**SUBJECT: URBAN DESIGN ADVISORY GROUP COMMENTS TO THE DRAFT
ENVIRONMENTAL IMPACT STATEMENT**

INTERSTATE 5 COLUMBIA RIVER CROSSING

DRAFT -Design Guidance for the Columbia River Crossing Project

Exhibit 3-10. Mill Plain Interchange

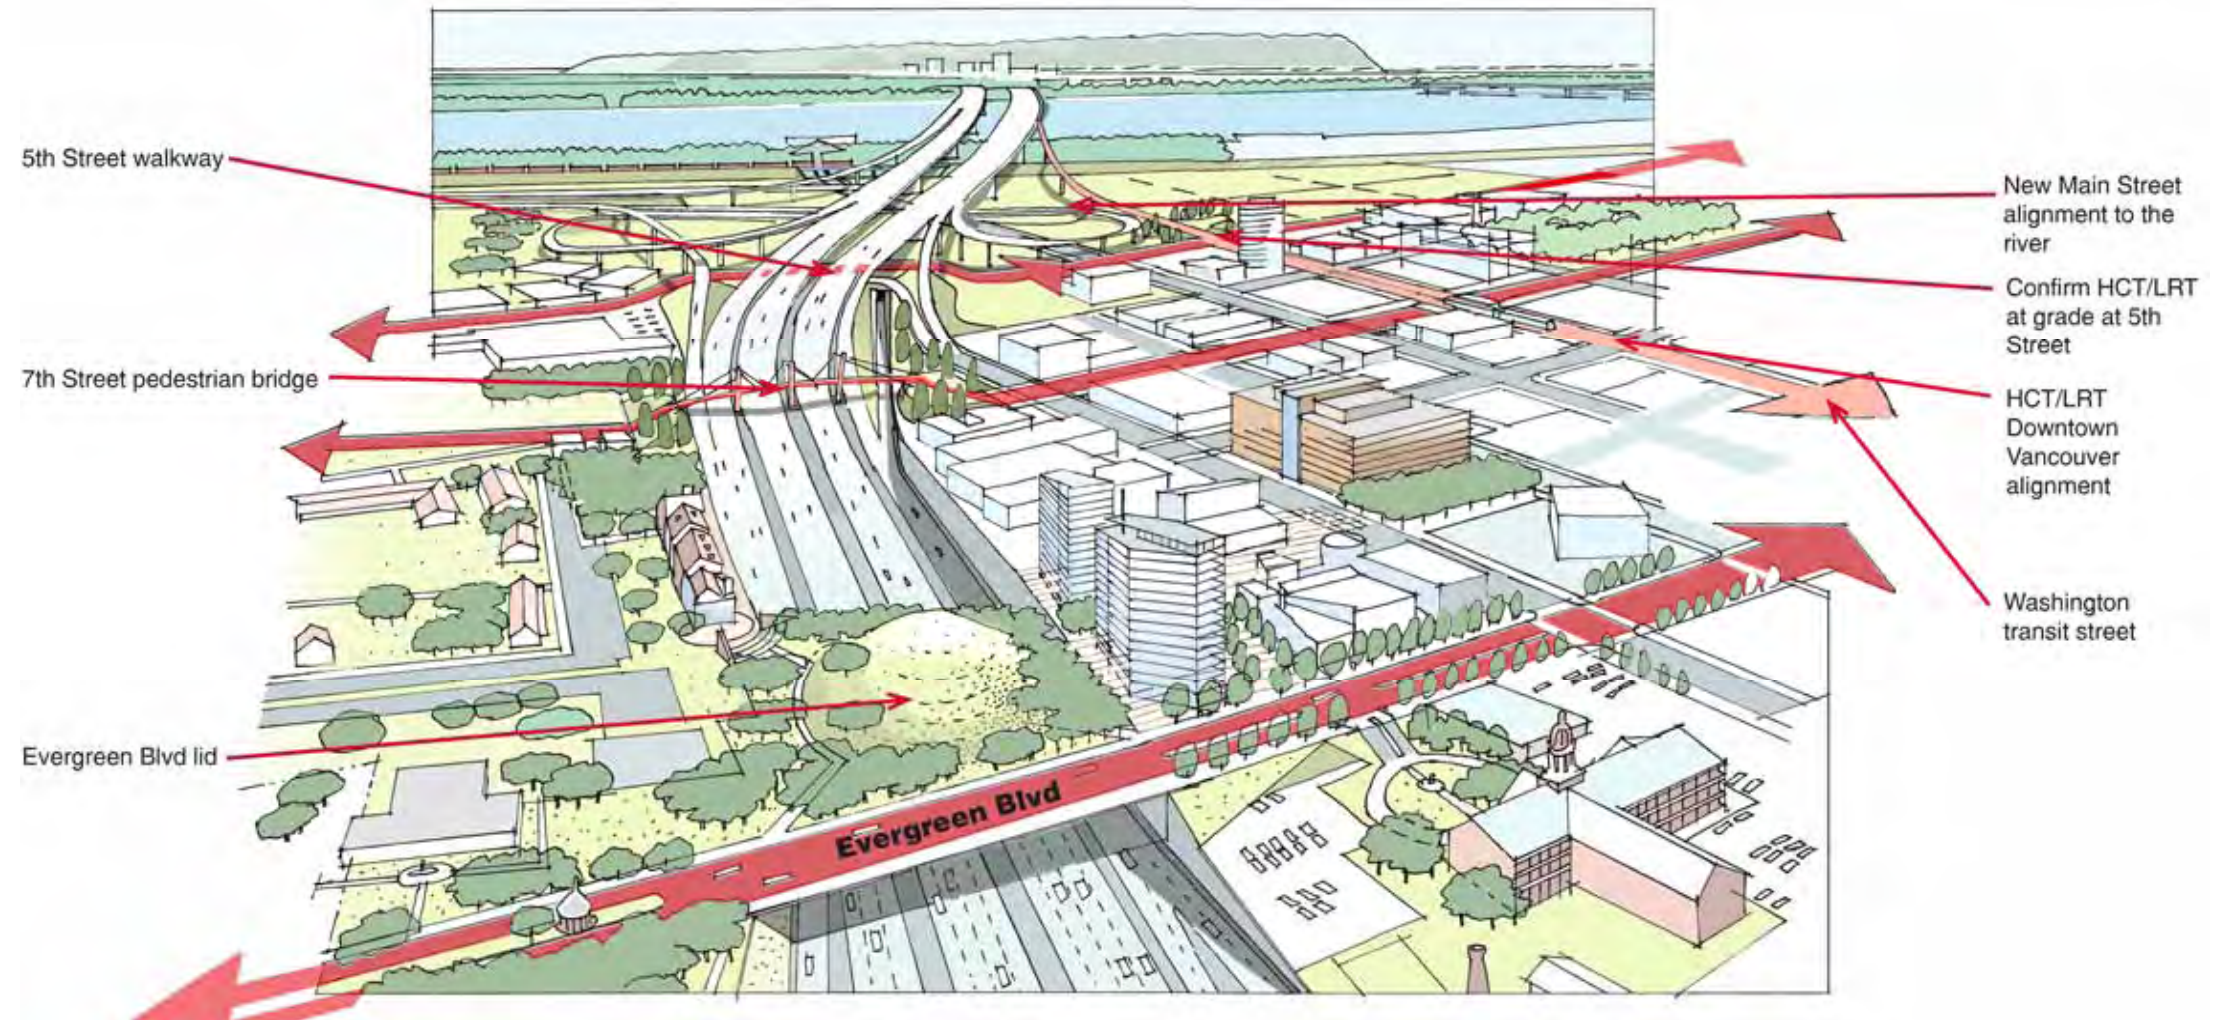
39. Provide safe and direct passage for pedestrians and cyclists on Mill Plain Blvd traveling between destinations east and west of I-5. (The current design appears to address only vehicular traffic needs. Prepare another design that accommodates all modes equitably). *Improve pedestrian and bicycle safety under I-5.*
